Lower Wishbone – Fulcrum Bolt –
Revised Torque Specification

MODEL 1995-96 MY
Sedan Range
VIN 720001-ON

ILLUSTRATION 1

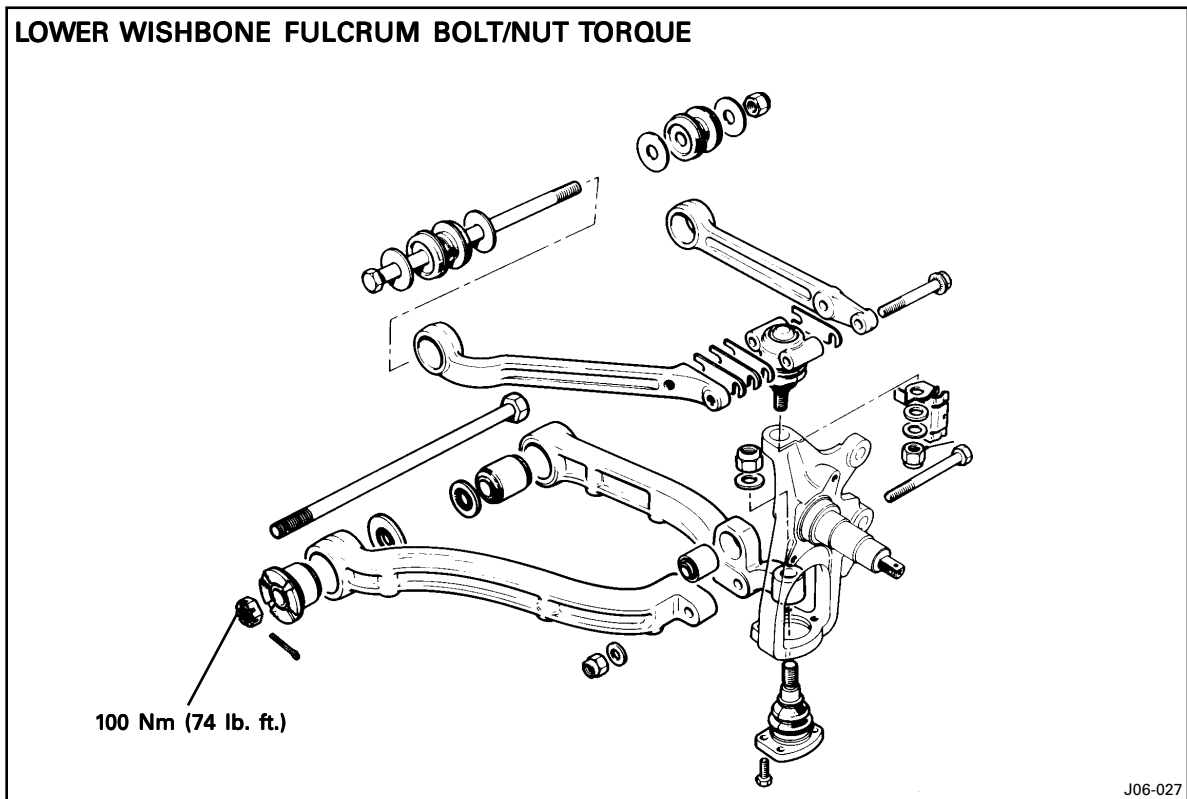
The torque specification of the lower wishbone fulcrum nut & bolt of the front suspension has been revised in production from VIN 774401.

The revised torque specification is 100 Nm (previously 55 Nm).

Use the revised torque specification of 100 Nm (74 lb. ft.) on **all** Sedan Range vehicles from VIN 720001 on, when performing service operations on the front suspension that require loosening or removing the lower wishbone fulcrum nut and/or bolt (Illustration 1).

There is **NO** need to apply the increased torque specification to existing vehicles in the VIN Range 720001-774400 unless the lower wishbone fulcrum nut and/or bolt are loosened.
